Proposal for draft amendments to Regulation No. 46
(Devices for indirect vision)

Note: The text reproduced below was prepared by the experts from the Netherlands in order to objectify the requirements for camera monitor systems. New text is given in **bold**, while deleted text is ~~crossed-out~~.

Figure 1 Diagram of the blooming measurement set-up. 1: Black & white background. 2: Lamps to make the background evenly illuminated. 3: Mirror. 4: high intensity light. 5: Camera. 6: Monitor.

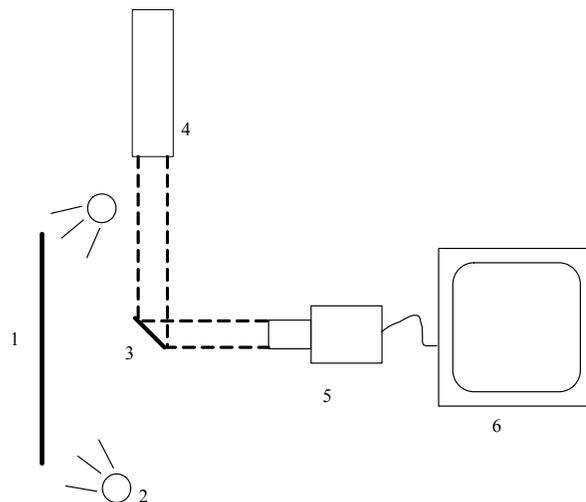
Amend Annex 9 to read:

A high-intensity light (e.g., theatre spotlight) is reflected into the image using a small mirror (see Figure 1). The illuminance of the camera by the light reflected from the mirror shall be 40,000 lx. The light source is depicted in the centre of the camera: the light enters the camera from the normal direction. A high contrast black and white pattern (e.g. a checkerboard pattern) is illuminated by a set of lamps to create an even illumination of 3000 (± 25%) lx.

The glare source should extend an angle (diameter) of 5° (± 10%). A schematic drawing of the set-up is given in Figure 1.

The mirror shall be placed such that its image is positioned in the middle of the pattern. The luminance contrast between the white and black areas in the display image can be measured. The saturated area is defined by the area in which the contrast of a high contrast test pattern falls below 0.2. The contrast (C) is defined by the difference in luminance between the bright (L_w) and dark (L_b ; black) and regions divided by the luminance of the bright (white) regions:

The saturated area shall not cover more than 10% of the display area.

In case the camera system shows dynamical changes in the blooming area during the test the maximum blooming area should fulfill the requirement.

This new annex contains a detailed measuring set-up for the test in which low sunlight falling on the camera is simulated.

Figure 2. Typical relationship between the size of the triangle and the fraction of correct responses.

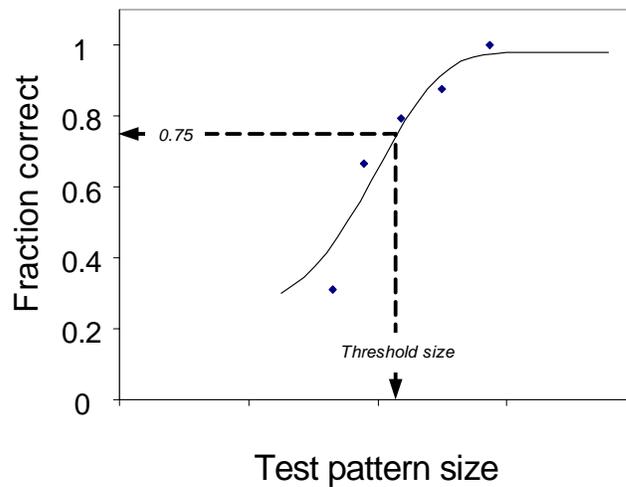
1.1.2 TOD test

The TNO Landolt C test can be used to determine the smallest discernable detail of the camera-monitor system. However, for sensor systems it is more suitable to use the TOD (Triangle Orientation Discrimination) method which is similar to the Landolt C method, but involves equilateral triangular test patterns. The Triangle Orientation Discrimination method is described in detail by Bijl & Valeton (1999),

who provide practical guidelines on how to perform a TOD measurement. In the method, triangular test patterns (see Figure 1) are viewed through the viewing system under test. Each triangle can have one out of four possible orientations (apex up, left, right or down) and the observer indicates/guesses for each triangle its orientation. When this procedure is repeated for many (randomly oriented) triangles of different sizes the fraction of correct responses can be plotted (see Figure 2), and increases with test pattern size. The threshold is defined as the point at which the fraction correct crosses the 0.75 level and can be obtained by fitting a smooth function through the data (see Bijl & Valetton, 1999). Critical perception is reached when the critical object diameter equals two times the width of the triangle at threshold size. The smallest discernable detail (ω_c) is equal to 0.25 times the width of the triangle at threshold size.

been replaced by a new procedure based on ophthalmologis tests like Landolt-C or TOD (Triangle Orientation Discrimination).
